60- and 66-MHz Pentium® Processor Specification Update

Release Date: February 1997

Order Number 243326-001

21. Power-Up BIST Failure

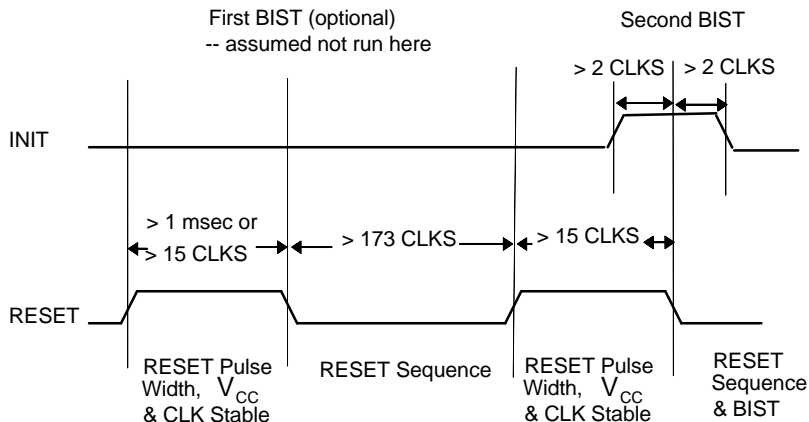
PROBLEM: The BIST (Built In Self Test) feature may fail.

IMPLICATION: Upon completion of BIST, a false failure may be reported. That is, a non-zero value may be returned in the EAX register, even though the part is operating correctly. As such, this erratum has no other product or system implications and is fully functional. To date, all observed false failures have returned a value of 20000H in EAX.

1. Invoke a double RESET — All false BIST failures have occurred during cold RESET. In order to accurately execute BIST, a double RESET sequence may be performed as shown in the figure below:

48. Asserting TRST# Pin or Issuing JTAG Instructions Does not Exit TAP Hi-Z State

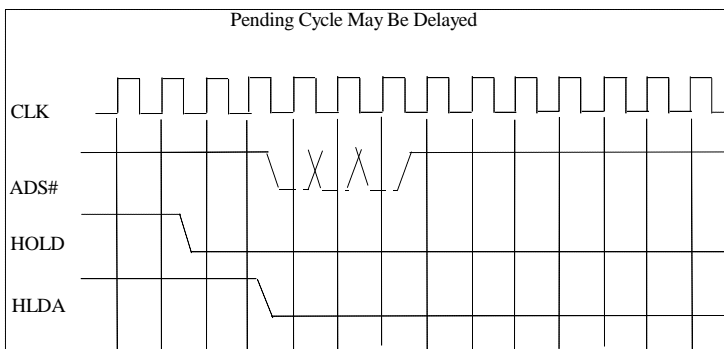
PROBLEM: The *Pentium® Processor Family Developer's Manual*, Volume 1 states that the TAP Hi-Z state can be terminated by resetting the TAP with the TRST# pin, by issuing another TAP instruction, or by entering the Test_Logic_Reset state. However, the indication that the processor has entered the TAP Hi-Z state is maintained until the next RESET. Therefore by using the above methods alone, the TAP Hi-Z state can not be terminated.

IMPLICATION: When the TAP Hi-Z instruction is enabled and executed, using the methods described in the *Pentium® Processor Family Developer's Manual*, Volume 1 may not terminate the Hi-Z state.

WORKAROUND: To exit TAP Hi-Z state, in addition to the methods described above, the processor needs to be RESET as well.

49. ADS# May Be Delayed After HLDA Deassertion

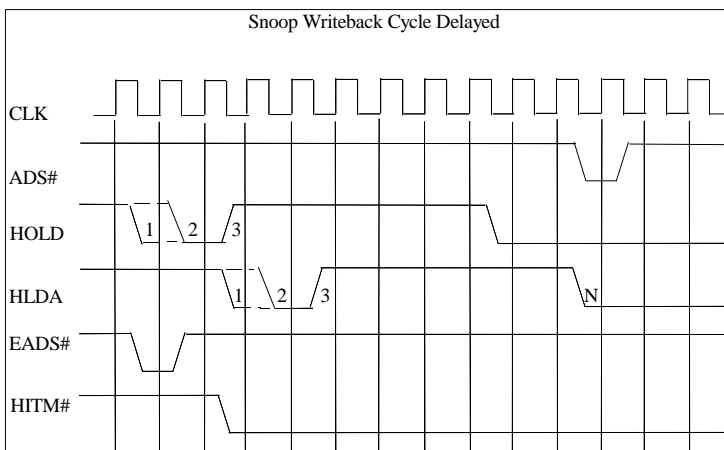
PROBLEM: The Pentium processor typically starts a pending bus cycle on the same clock that HLDA is deasserted. However, it may be delayed by as many as two clocks. See the diagram below.

In two cases, for example, if HOLD is deasserted for one clock (i.e., clock 2) or two clocks (i.e., clocks 1 & 2) and then reasserted, the window may not be large enough to start a pending snoop writeback cycle. The writeback cycle may be delayed until the HLDA is deasserted again (i.e., clock N). See diagram below.

IMPLICATION: If the system expects a cycle, for example a writeback cycle, and depends on this cycle to commence within the HLDA deassertion window, then the system may not complete the handshake and cause a hang.

1. Deassert HOLD for at least 3 clocks (i.e., clocks 1, 2, and 3 shown in figure) before reasserting HOLD again. This ensures that the Pentium processor initiates any pending cycles before reasserting HLDA.
2. If the system is waiting for the snoop writeback cycle to commence, for instance if HITM# is asserted, the system should wait for the ADS# before reasserting HOLD.
